Addendum No. 1

Re: Part B - James M. Seals, JR. Park – Athletic Restroom/ Concession and Field Improvements
504 Texas Street, Mobile, AL 36603
Project No. PR-041-20
Part C - Hackmeyer Park – Improvements Phase 2
3810 Conway Drive South, Mobile, AL 36608
Project No. PR-034-21

Date: November 14, 2022

SCALE: 1/4"=1'-0"

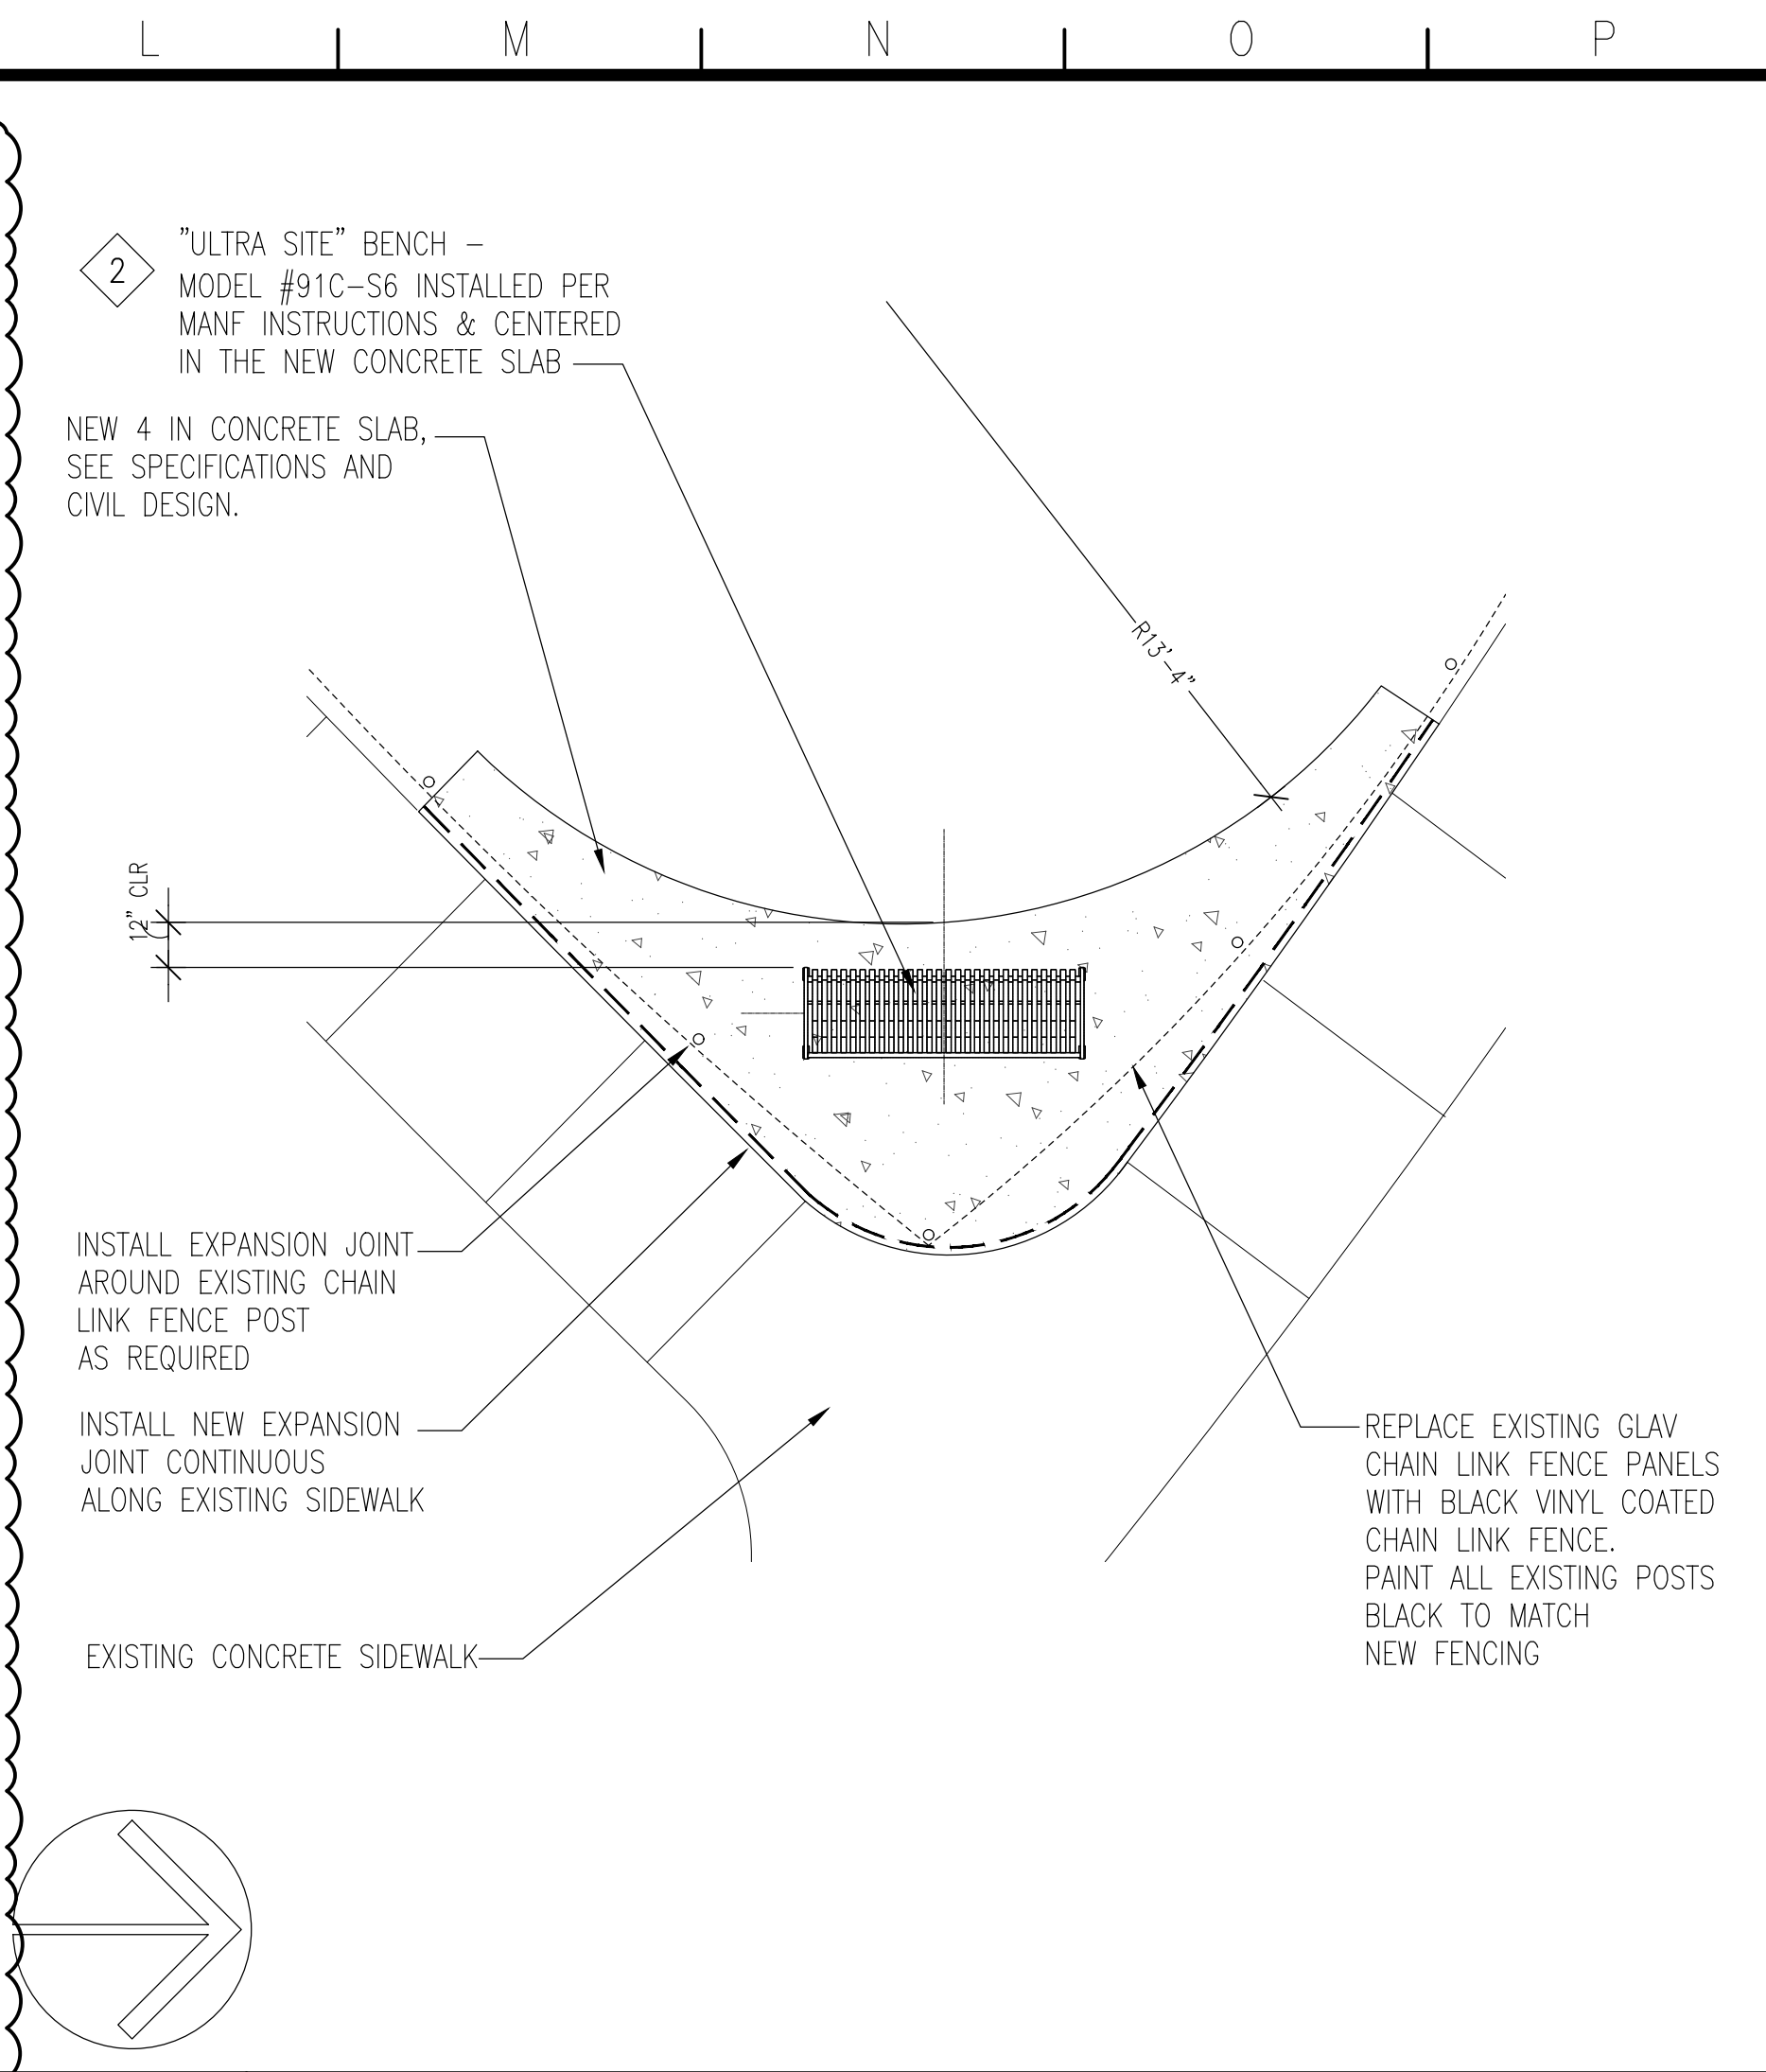
- Item 4: Sheet A1.3 Details – Park Furnishings
Replace this sheet dated 11.02.22 with the attached revised sheet of same title A1.3, dated November 07, 2022 and labeled Revision 01 (Addendum No. 1). Substantial changes include the following:
Revise Detail D/A1.3 to relocate doggie drinking fountain & bench.

2 NEW SHADING DEVICE - TYPE A (LARGE)

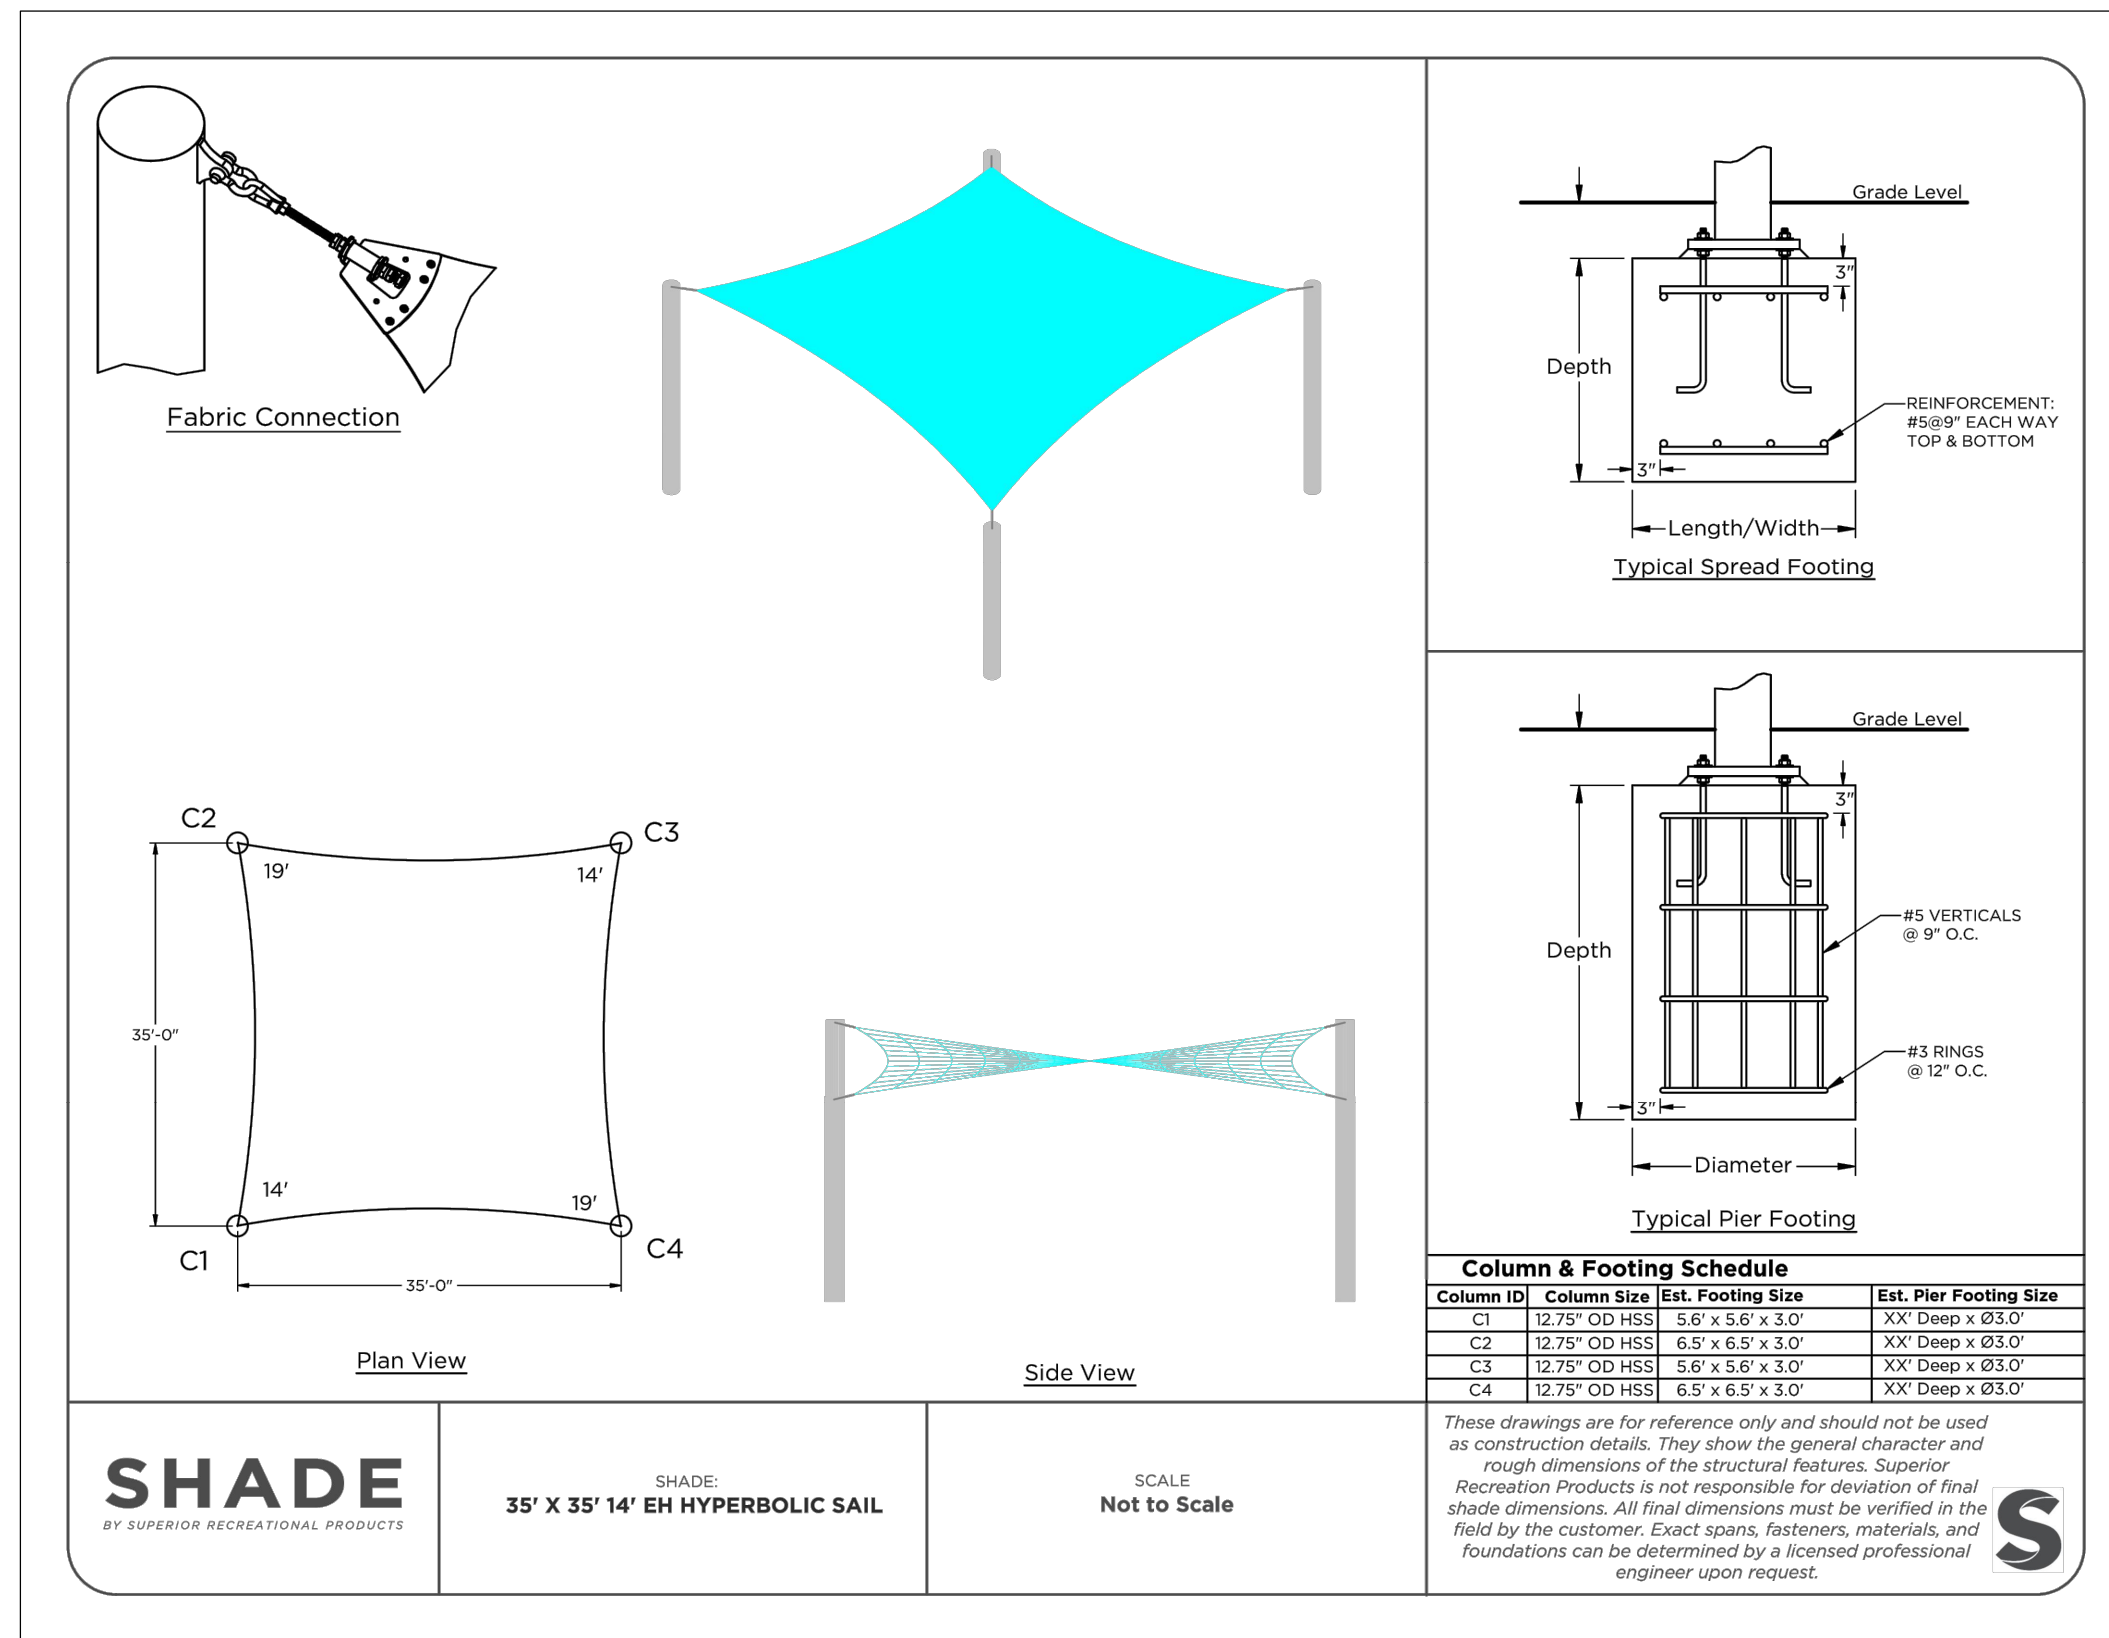
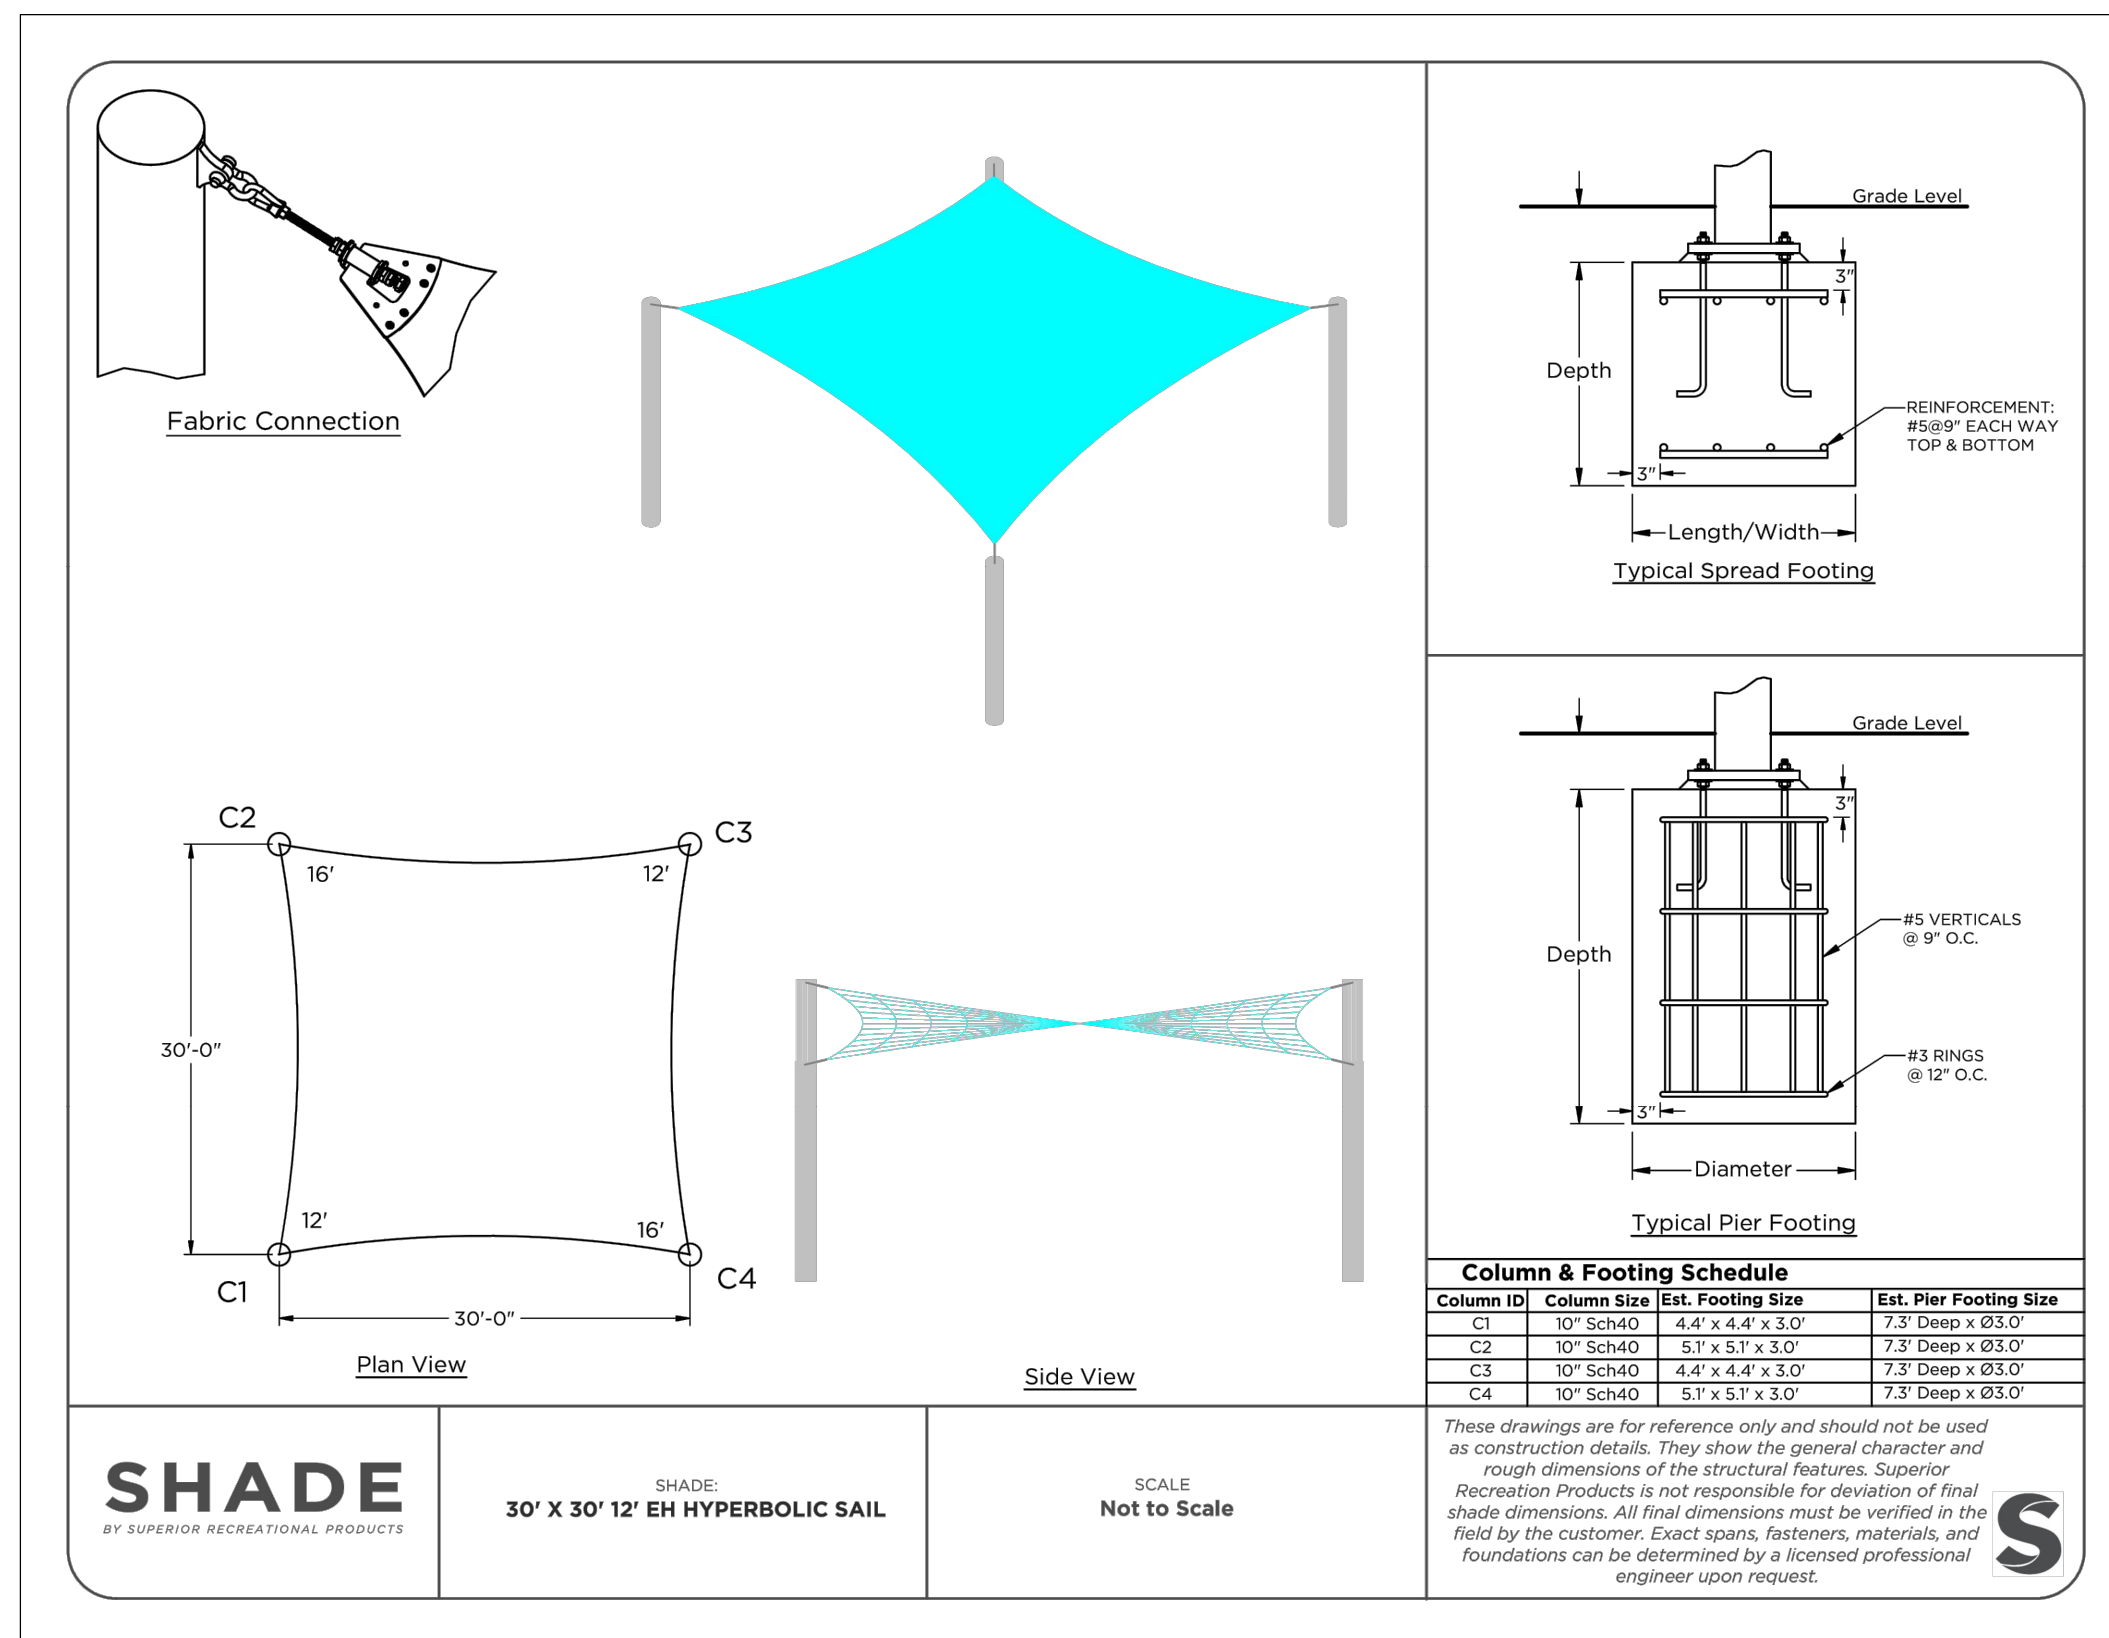
- Item 7: Sheet A4.2 Playground Shading Devices

Replace this sheet dated 11.02.22 with the attached revised sheet of same title A4.1, dated November 07, 2022 and labeled Revision 01 (Addendum No. 1). Substantial changes include the following:

Revise Add Alternate # - Change Shading Devices from Add Alt #1 to Add Alt #2
